TOWN OF DISCOVERY BAY

NOTICE OF THE REGULAR MEETING
OF THE BOARD OF DIRECTORS
OF THE TOWN OF DISCOVERY BAY
October 07, 2026 07:00 PM

G.1 Discussion and Possible Action to (1) Find Anderson Pacific Engineering Construction Not a Responsible Bidder, Reject Its Bid, and Award the Construction Contract to the Next Lowest Responsible Bidder; or (2) Find Anderson Pacific Engineering Construction a Responsible Bidder and Award the Construction Contract to Anderson Pacific Engineering Construction as the Lowest Responsible Bidder, for the Discovery Bay Sewage Treatment Plants 2025 Capital Improvements Project. Page 16

Discovery Bay Sewage Treatment Plants
2025 Capital Improvements Project

DRAWING C-201

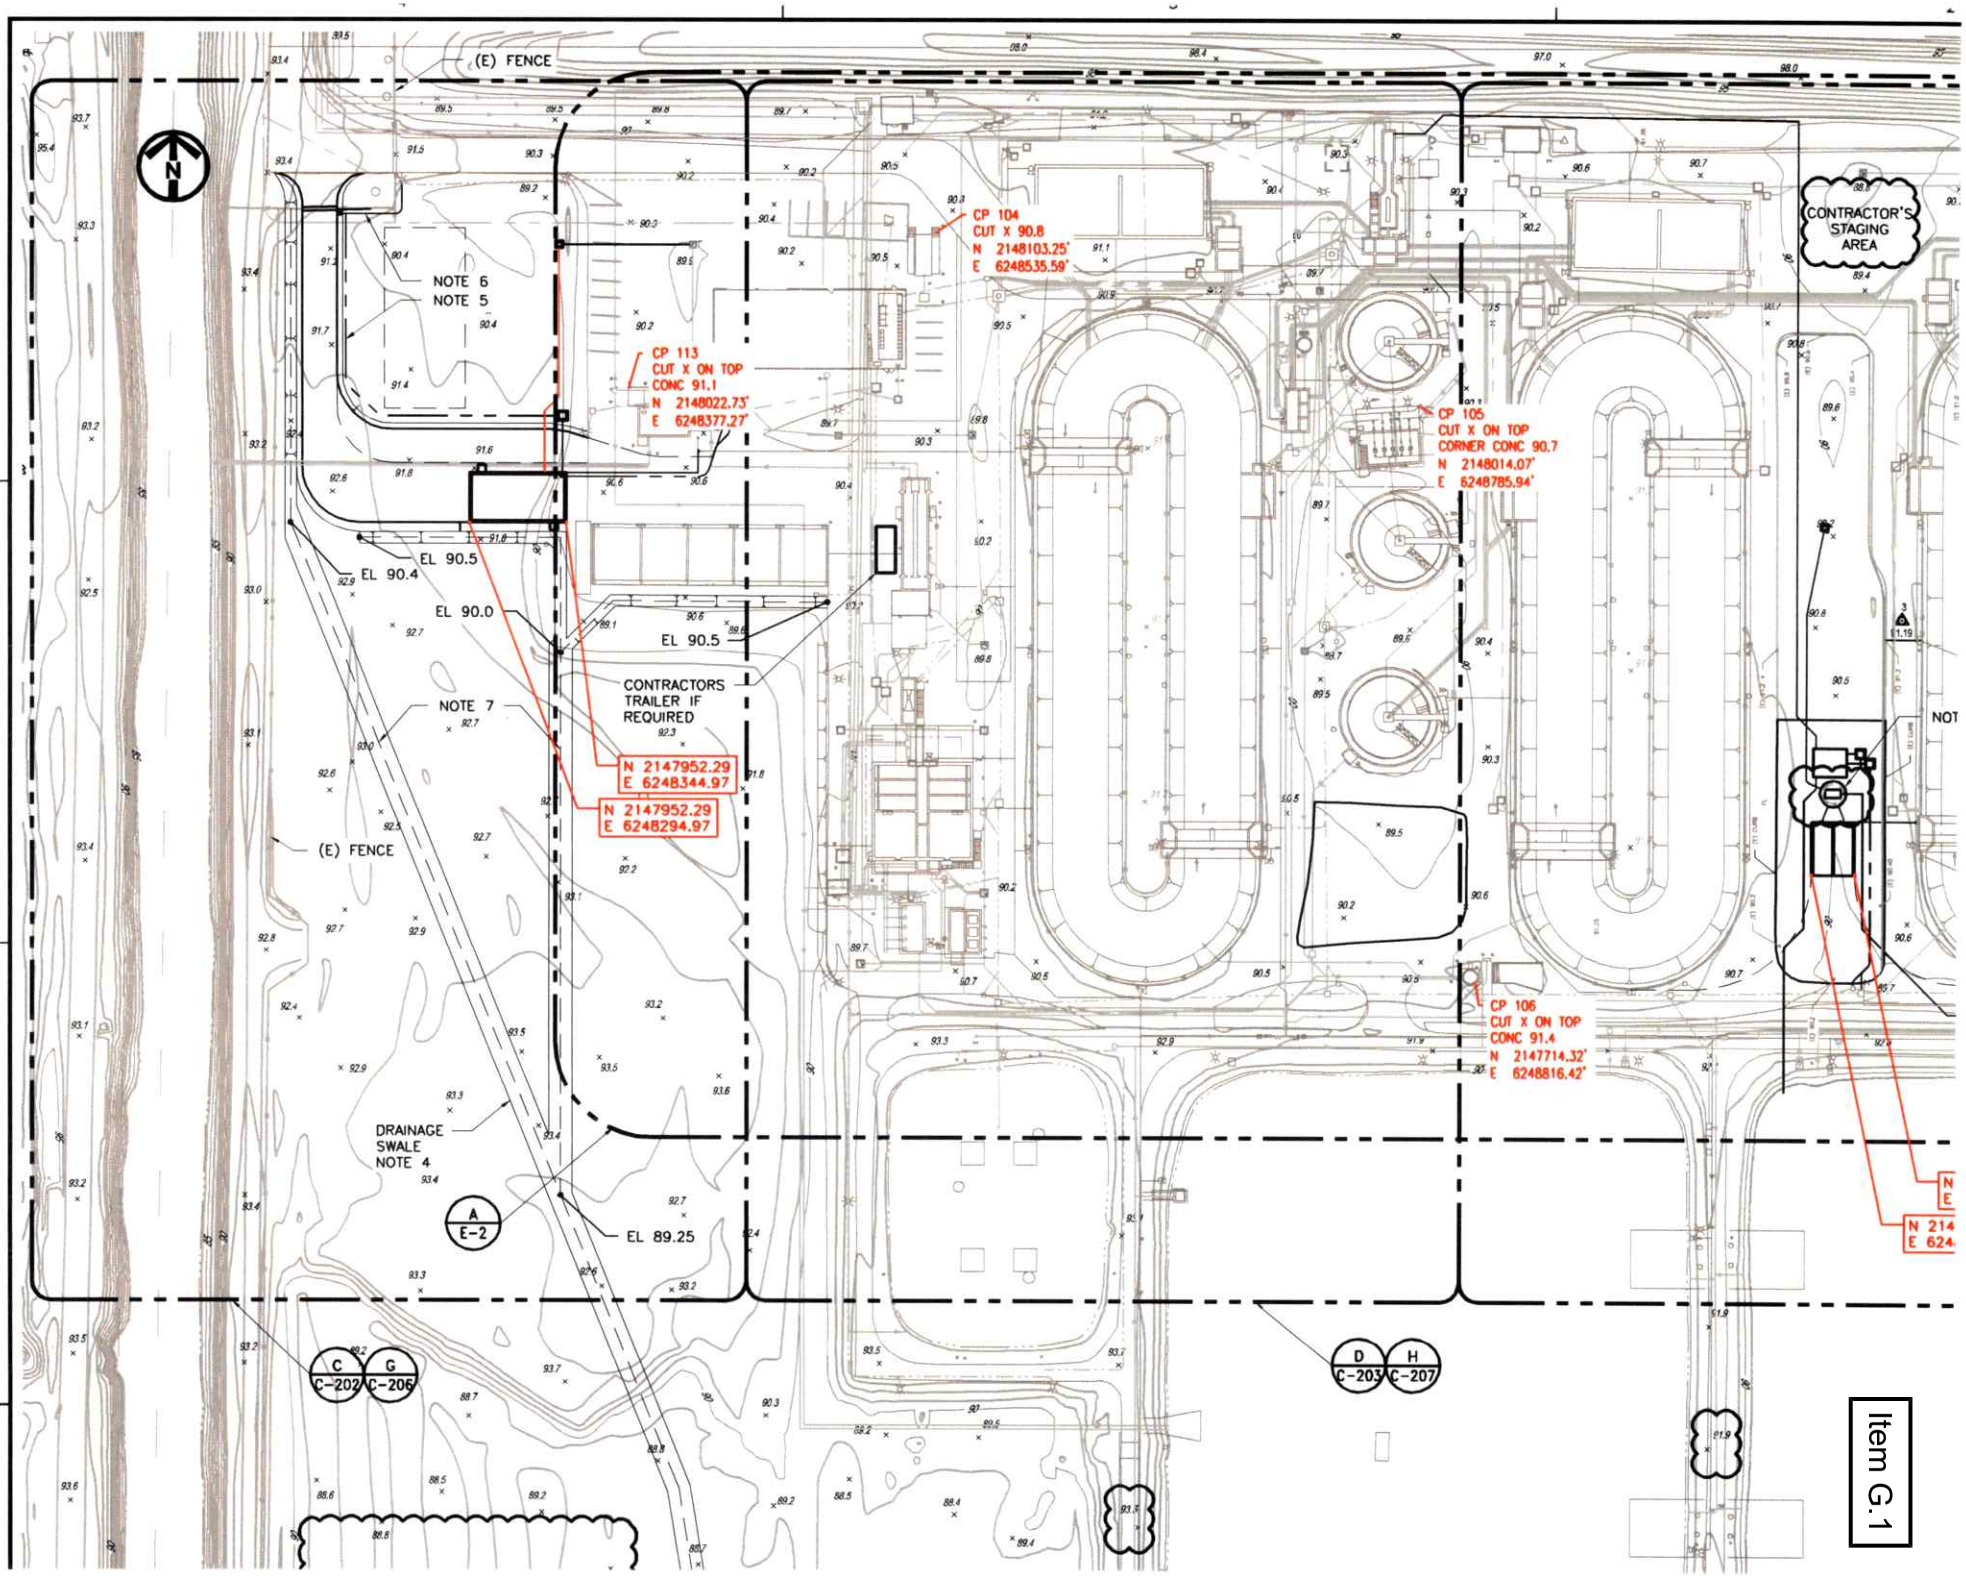
3			Is night work allowed for the work in the Solar Dryers to avoid heat issues?	Night work will be allowed for work directly in the solar dryers only. Contractor shall have a minimum of 2 people on site for this activity. Contractor is responsible for all safety equipment and protocols during all construction and for all night work taking place in the dryers.
4			Can you provide the type of pipe the 1" IA is (on Drawing M-5).	The 1" HPA and 1" IA are called out in the piping schedule as HPA/IA (Specification Section 15052, Page 9).The piping Schedule will be clarified in this Addendum to read HPA & IA. The 3" W referenced in Notes 6 & 12 should be 3" PW as shown on the Plan View. This modification is reflected in this Addendum.
5			Section 01722 Field Engineering does not clarify who is responsible for staking. Is the Town providing this or do we need to include this in our proposal?	The Owner and Engineering are not providing any surveying services on this project. Specification Section 01722 for field engineering describes work to be performed by the Contractor, including all field layout and staking. The only exception is the basic reference line and bench marks provided by the Owner as stated in Specification Section 01722, 1.04.A. We have added existing reference coordinates and bench mark information internal to the plant at several locations to the drawings and provided coordinates of the new structures on the drawings. Contractor is responsible to extend surveying control to your individual work areas and all other survey requirements. See modified Drawing C-201-A2 and C-206-A2 in this Addendum.

1. Replace Drawing C-201 with the attached Drawing C-201-A2.

DRAWING C-206

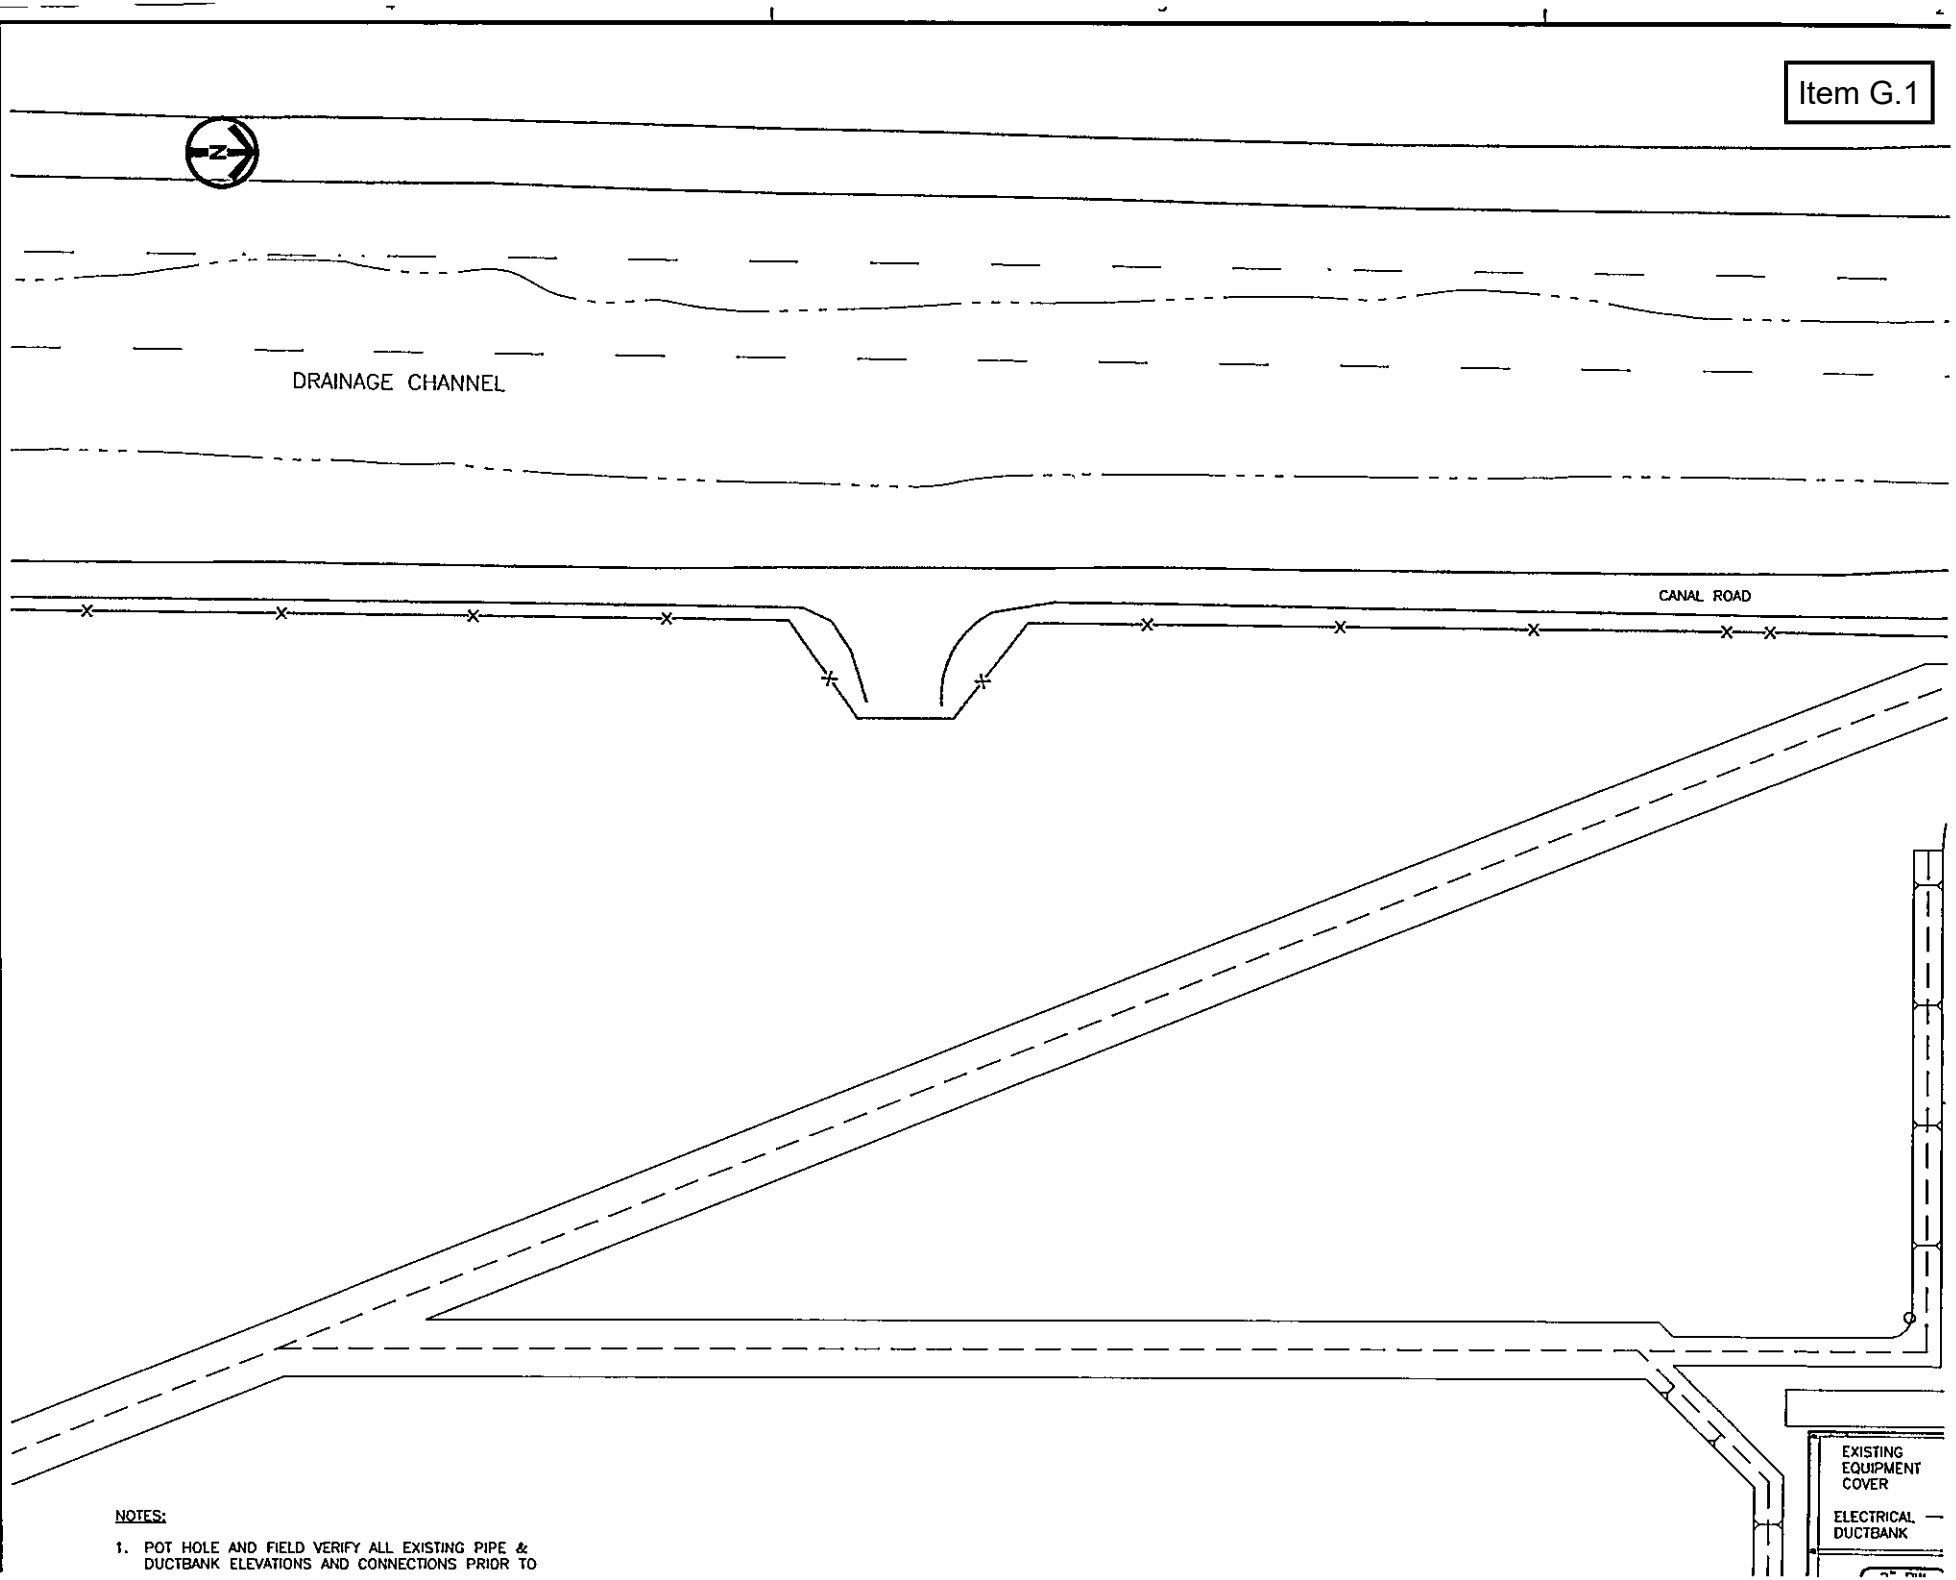
Item No.	Spec Section	Drawing Reference	Question	Response
1			Is there a weight limit above the 24" EFF Pipe shown parallel to the new Vacuum Truck Building on Drawing C-206?	The existing pipe is currently approximately 6 feet below current grade. When the road is excavated for the subbase, the remaining cover will only be approximately 3.5 feet. Heavy crane loads or other point loads should be avoided on top of the pipe once the road section is excavated until AB is placed. Contractor shall locate the Effluent Line prior to construction in this area.
2			Will the Owner mark the utilities prior to construction?	The Engineer will provide copies of existing drawings showing the approximate location of existing utilities. Contractor shall carefully pothole for all existing utilities in work areas Per Section 01140-1.05.C of the project specifications. The Owner will not mark the location of utilities.

5			Sheets S-3 and S-4 indicate a 4-inch underslab drain system; however, Sheet C-206 does not depict the continuation of the associated yard piping. Please provide clarification regarding the proposed routing and the intended point of connection for this line, along with any additional direction necessary for coordination and installation.	This piping was clarified on Drawing C-206-A2 in Addendum No.2.

1. Replace Drawing C-206 with the attached Drawing C-206-A2.
